READING PARK STATION
RPA for trees Caversham Rd

PLANNING INSPECTORATE REFERENCE: APP/E0345/W/21/3289748
READING BOROUGH COUNCIL PLANNING REFERENCE: 200328/OUT
18th August 2022

INSPECTOR'S NOTE TO PARTIES 27.7.22

Figure 1 – Trees in relation to the existing building on site

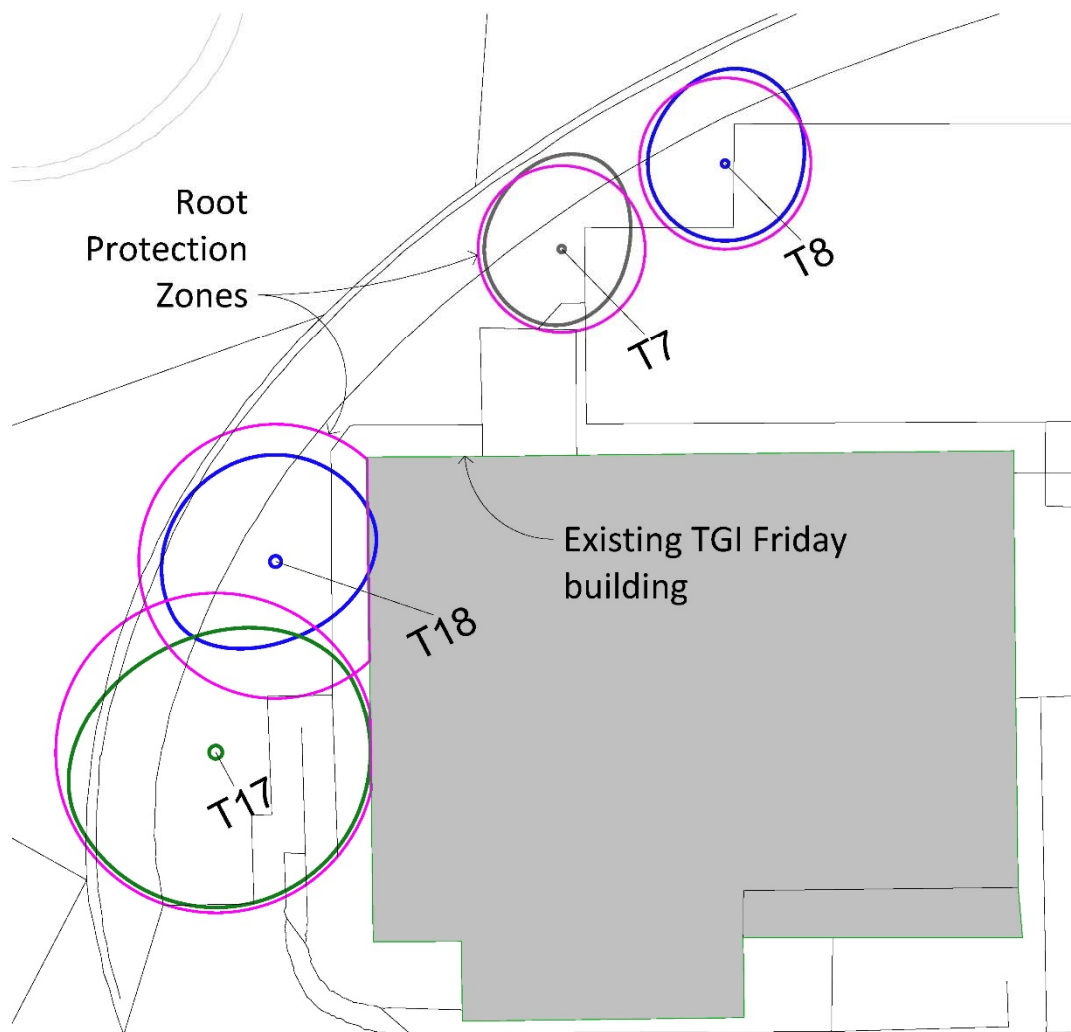
- Appellants to consider RPA for trees on Caversham Road – do parameter plans encroach and how would this be dealt with?

- There are 4 trees on the Caversham Road frontage adjacent to Plot A
- It is a reasonable assumption to assume the RPZs of T17-18 would only extend to the existing building line and not beyond, due to the foundations of the existing building
- T7 and T8 are set in a planting bed adjacent to parking areas
- T17 and T18 are in a grassed area immediately adjacent to the existing building (TGI Fridays)
